ADDENDUM

Project: Midvalley 2.4.6

Addendum No.: 1

Date: 28 May 2019

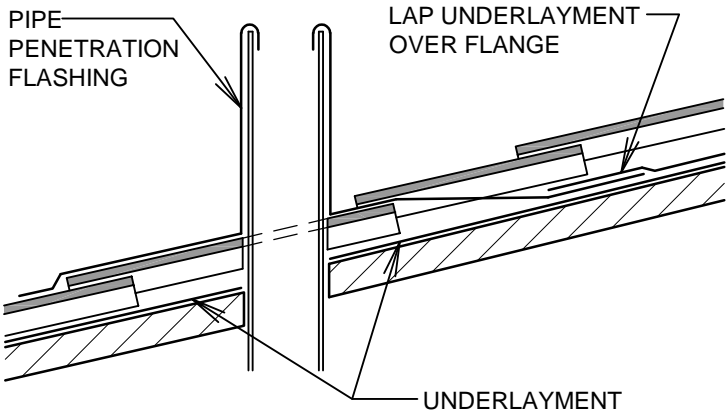
- a. At landscape areas noted in Keyed Demolition Note #4 and Keyed Note #4, remove (3) existing shrubs (see photograph below) and replace with (3) new 5 gal shrubs to match at completion of sewer connection work.

VENT PIPE PENETRATION

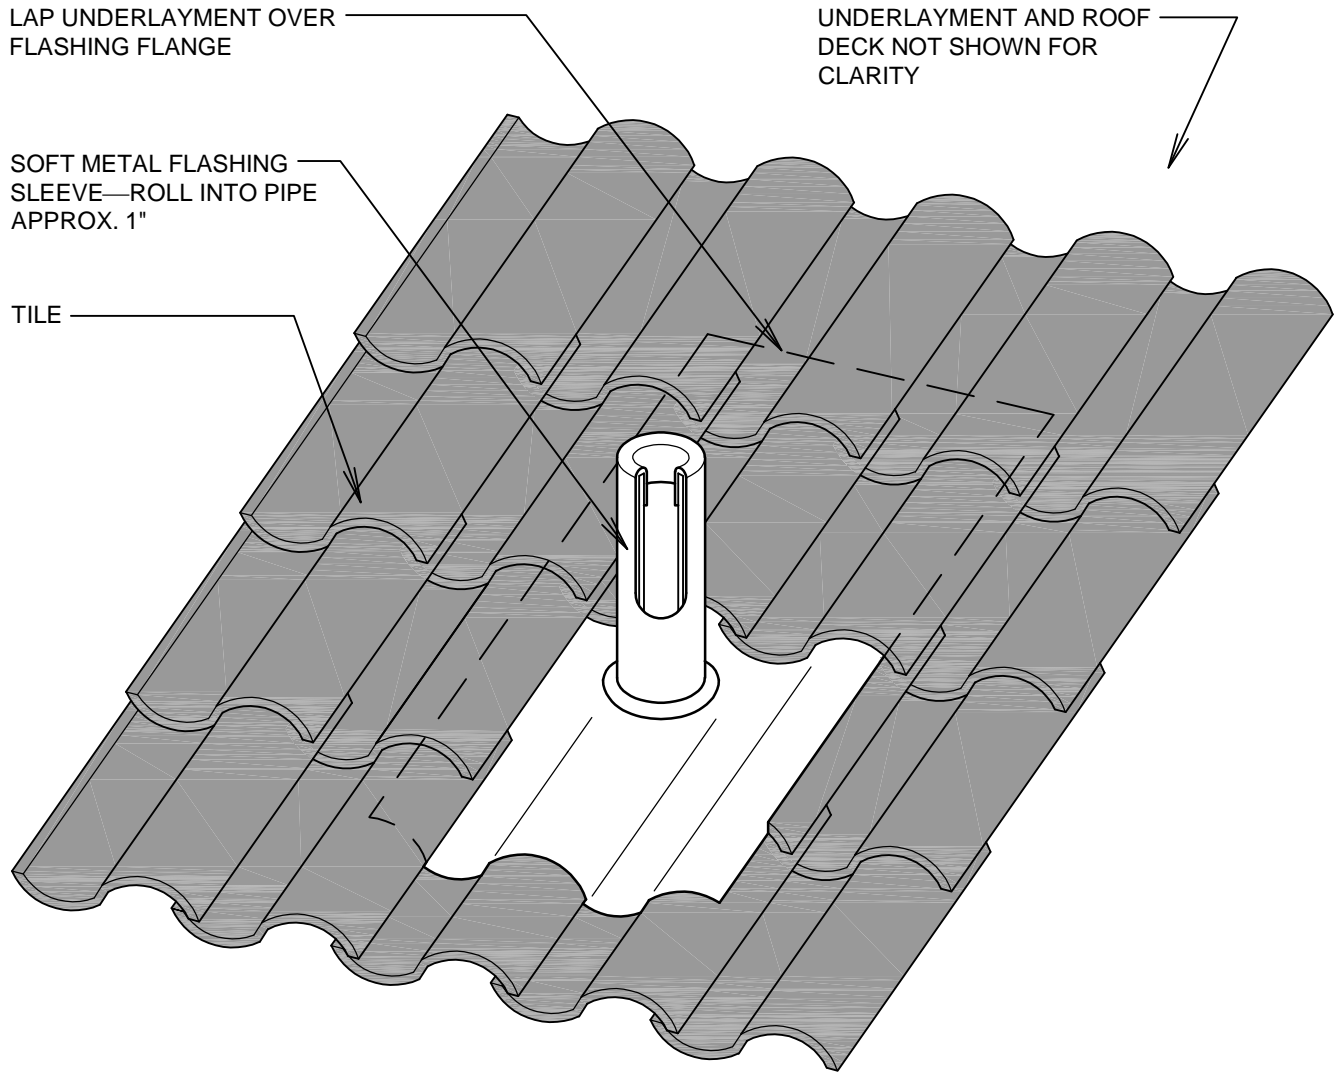
- a. Existing roof is concrete tile materials. Replace Detail A/A151 with attached revised detail A/A151 showing vent pipe flashing for tile roofing materials and see Item D.1. above.

- Item D.1.** Omit Section 07 6310, Steep Slope Roof Flashing: Asphalt Shingles and replace with below portions of Section 07 6310, Steep Slope Roof Flashing: Concrete Roof Tile for vent pipe flashing materials. See also Item E.2. below.
